TOWNSHIP OF FRANKLIN
Board of Adjustment
Agenda
Thursday, November 6, 2025

UKRAINIAN ORTHODOX CHURCH OF U.S.A / ZBA-25-00008

D(2) Use Variance, Preliminary & Final Site Plan w/C Variances in which the proposal consists of site modifications associated with the retention of certain existing (church and seminary) facilities at 135 Davidson Avenue, Somerset; Block 469 Lot 1.06 in zone B-I

RE: ***Ukrainian Orthodox Church of U.S.A.
Parking Lot Improvements
Preliminary & Final Major Site Plan
Report #2
Engineering
Block 469, Proposed Lot 1.09
135 Davidson Avenue
Franklin, New Jersey
Our File: MFRZ0469.03/600.01
Application # ZBA-25-00007***

Figure 2: FEMA Special Flood Hazard Area along stream and in roadway

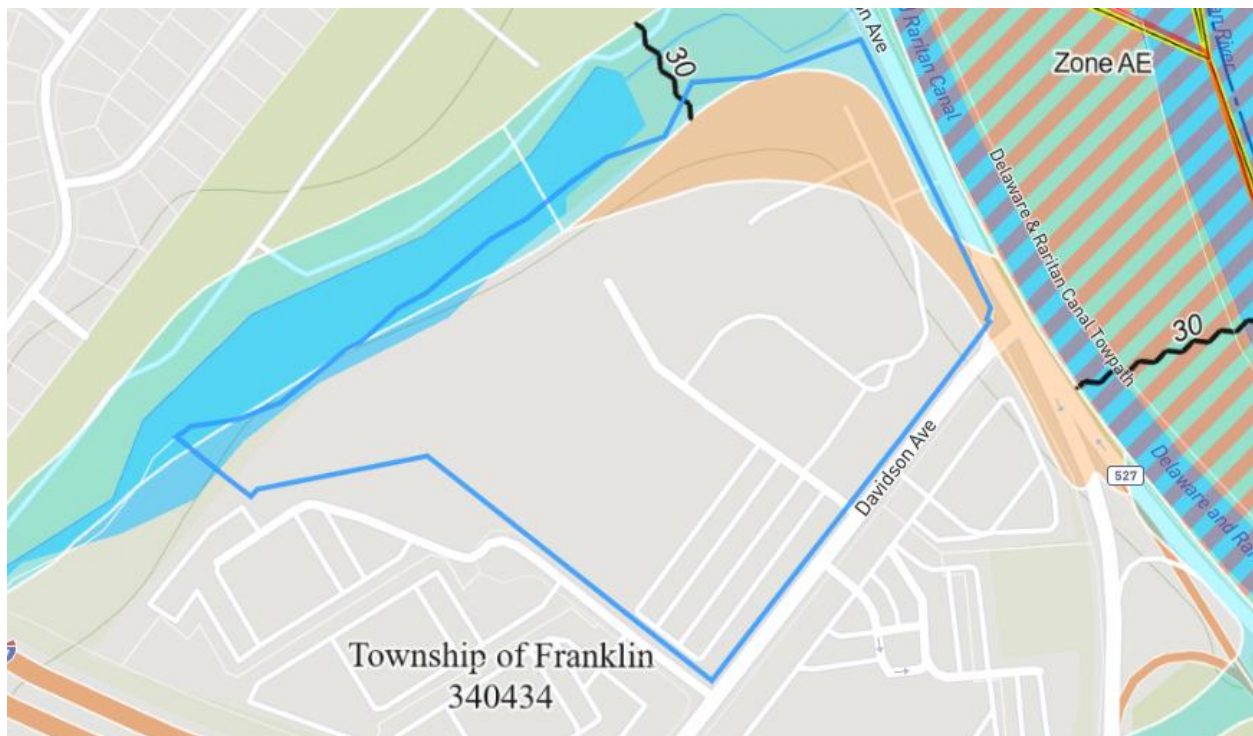
- FEMA records show a Special Flood Hazard Area on a portion of the property.
- GIS information provided by the NJDEP indicates that wetland areas may exist on a portion of the property.
- The applicant is proposing to subdivide the property into two lots, fully conforming in size and all bulk requirement for the zone. A variance is required for expansion of a non-conforming use; the church and cultural center are preexisting non-conforming uses in the B-I Zone.
- It is presumed that the applicant is proposing to perfect the minor subdivision by deed filing with the County.

Figure 5: Proposed Subdivision (ZBA-25-00008)

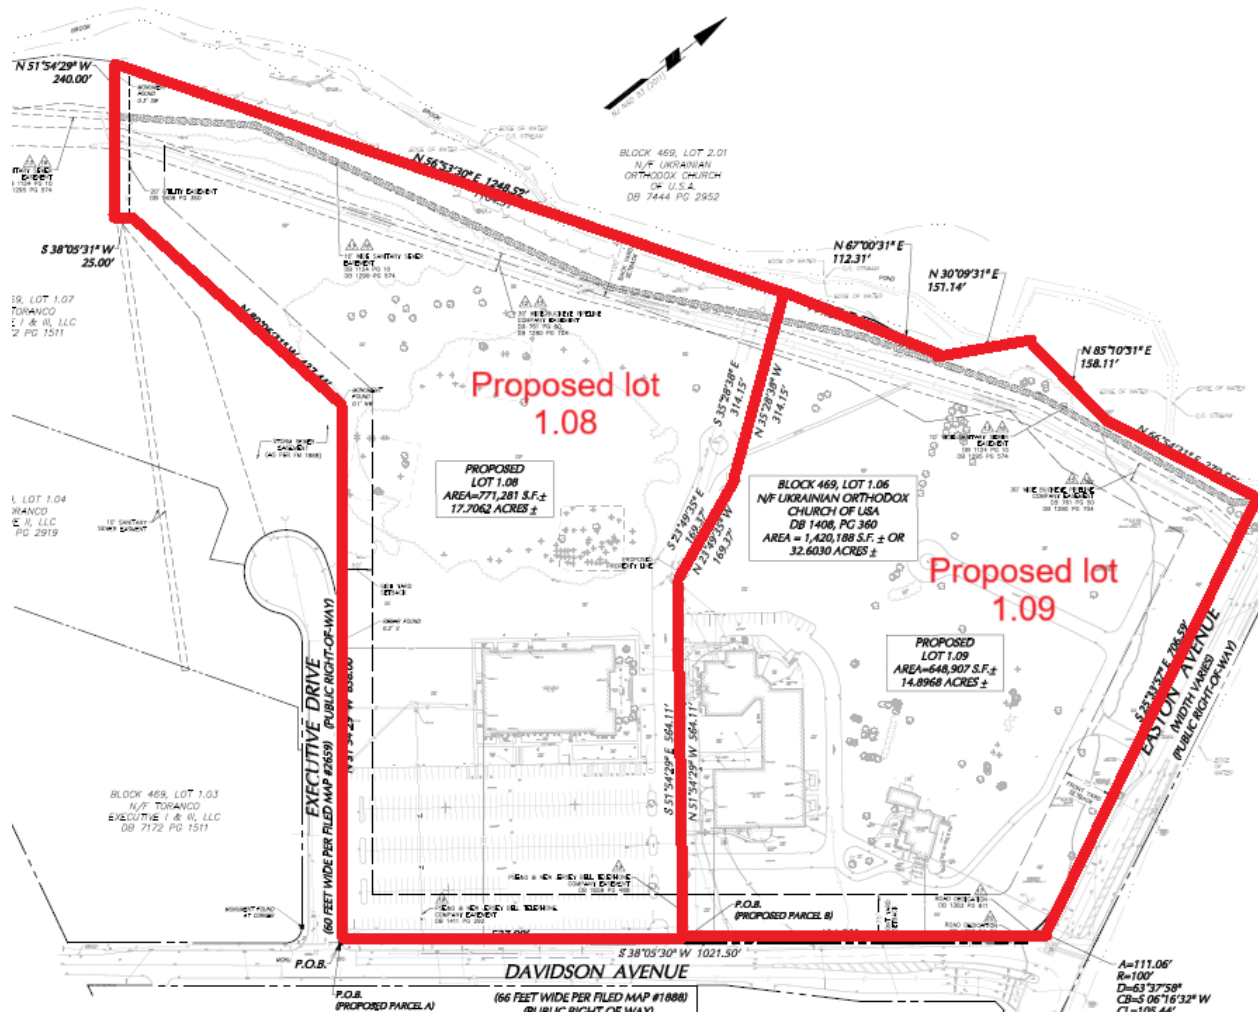
1. The proposed subdivision plan reflects two proposed lots that significantly exceed minimal lot area and frontage requirements and comply with all applicable bulk requirements based on the existing facilities on the site. No bulk variances are required.
2. The application should address necessary coordination between the two proposed lots both with and without the proposed construction reflected on the site plans. This would include, as necessary, easements related to parking, access, utilities and/or drainage.
